Bulletin No.: 14284A
Date: April 2016

Program Bulletin

CUSTOMER SATISFACTION PROGRAM

SUBJECT: Upfitter Auxiliary Switches
MODELS: 2014 Chevrolet Silverado 1500
2015 Chevrolet Silverado
2014 GMC Sierra 1500
2015 GMC Sierra
Equipped with Auxiliary Switch Bank (RPO 9L7)

3963531

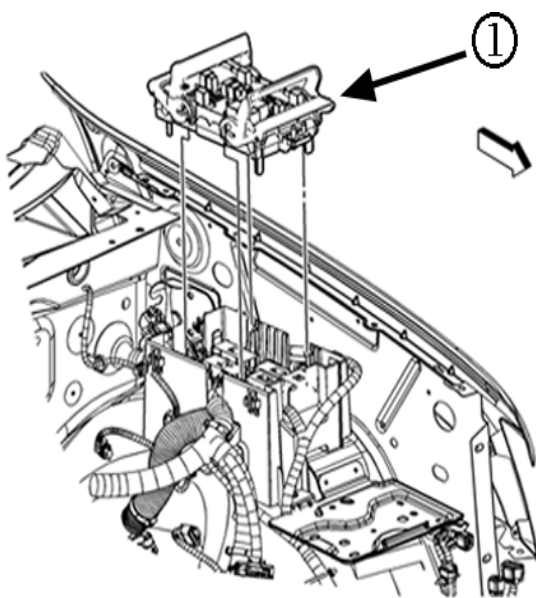
Certain 2014 and 2015 model year Chevrolet Silverado and GMC Sierra vehicles equipped with the Auxiliary Switch Bank (RPO 9L7) may have an electrical issue created when one or both Upfitter fuses used for the instrument panel mounted auxiliary switch bank are moved from the battery feed to the ignition feed position. If the fuse positions are altered, the engine could continue to run after the ignition switch is turned off. There could also be an inadvertent glowing of the auxiliary switch indicators, additional parasitic current drain, or a no start condition.

1. Remove the underhood electrical center (1). Refer to *Underhood Electrical Center or Junction Block Replacement* in SI.
2. Install the new underhood electrical center. Refer to *Underhood Electrical Center or Junction Block Replacement* in SI.
